Access Compliance Report

Public Rights-of-Way

| Intersection ID: 23966 | Main Street: CAROLINA_PAVILION_DR_N | Cross Street: SOUTH_BV | Location: SE |
| ADA ID: 1C8B85CDBA80 | Ramp Type: PerpDiag | Initial Pass/Fail: Pass | Overall Compliance: No |

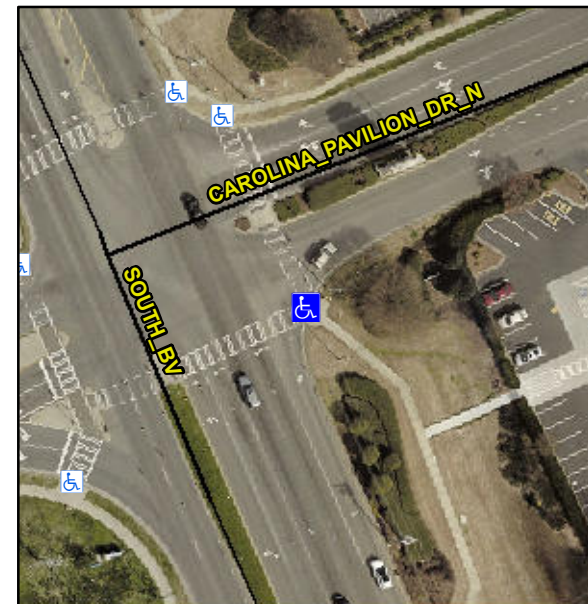
Not Found, R304.2.1, R304.2.2-Perp, R304.3.2-Para, R305.1.4, R305.2

| Compliance | Description | Data | Compliance | Description | Data |
|------------|-----------------------|--------|------------|-----------------------------|-------|
| No | Landing Length (in) | 42.0 | Yes | DWS Provided? | Yes |
| No | Landing Slope (%) | 3.2 | Yes | DWS Length (in) | 24.0 |
| Yes | Landing X Slope (%) | 0.6 | No | DWS Full Width? | No |
| N/A | Landing Curb? (Y/N) | No | No | DWS Offset (in) | 4.0 |

Remove & Replace Curb Ramp With Two New Directional Ramps or Equivalent.
